Douglas LUTS - Work Packages WP1, WP2 & WP11

I refer to the above Part VIII consultation processes.

1. Work Package No. 1 – N40 Underbridge Works (Douglas West)

2. Work Package 2 - N40 Underbridge Works (Douglas West) South Douglas Road

Figure 1 – Underpass looking south east showing the visibility problems as one emerges from the underpass

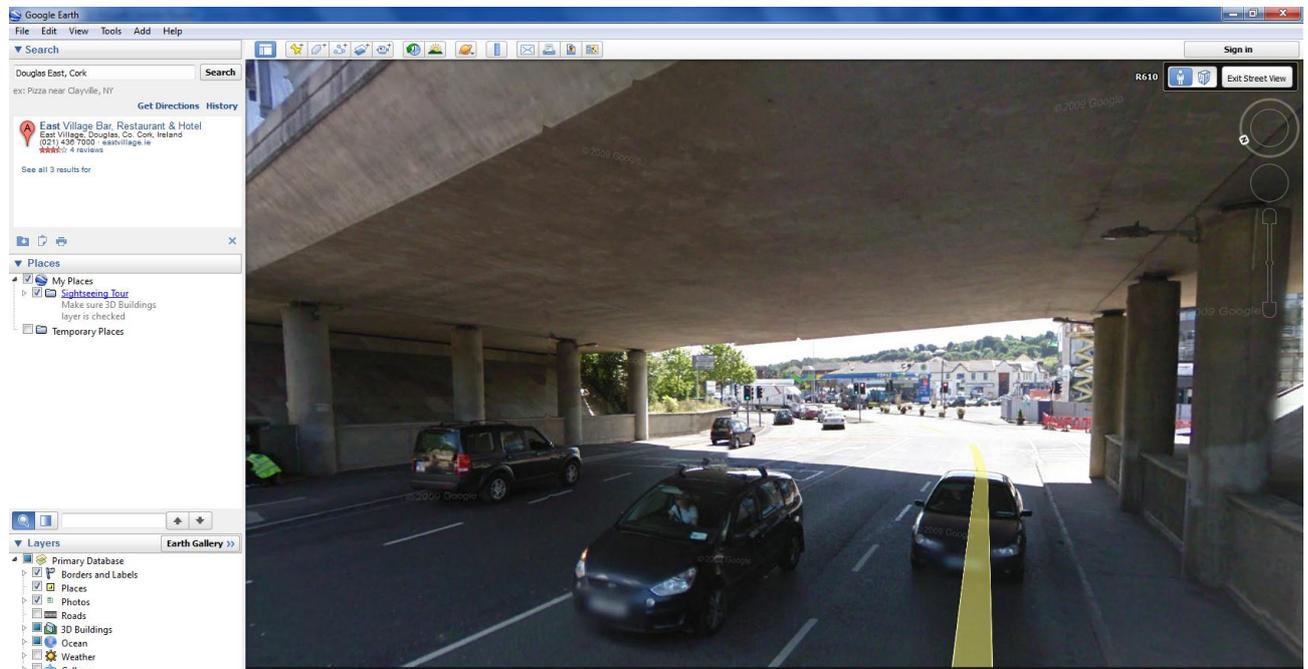
It is unclear, for example, how the transition from the proposed cycle-lane plus two general traffic lanes to two general traffic lanes only will be designed. As is, it seems that cyclists emerging from this cycle lane will vie with two streams of general traffic as they approach what will effectively be a pinch-point between the kerb and traffic island. This is particularly problematic in the context of car/truck drivers emerging from the relative darkness of the underbridge into the light *where they may be temporarily blinded within the space that cyclists are merging with general traffic*. This problem is shown clearly in the Google Earth image of the underpass – Figure 1 below.

The whole design needs to be reconsidered as a matter of urgency: it is not enough to propose a short length of a cycle lane and then expect cycling conditions in the adjacent spaces to improve.

At the very least, for these merging spaces the scheme designers should introduce a 30kph speed limit so as to make it easier for different types of road users to interact safely with each other. It is noted in “Figure 1.0: Douglas Village Work Packages” (on page 1 of the Part 8 Planning Application) that 30kph speed limits are proposed in other parts of the Douglas LUTS area. It would enhance safety considerably if the 30kph zones were expanded to include those locations in which cyclists were entering and emerging from cycle lanes and the underpasses. Furthermore, the designers should consider providing very large bicycle symbols on the general lanes at strategic locations in the vicinity of any dedicated cycle facilities that are provided.
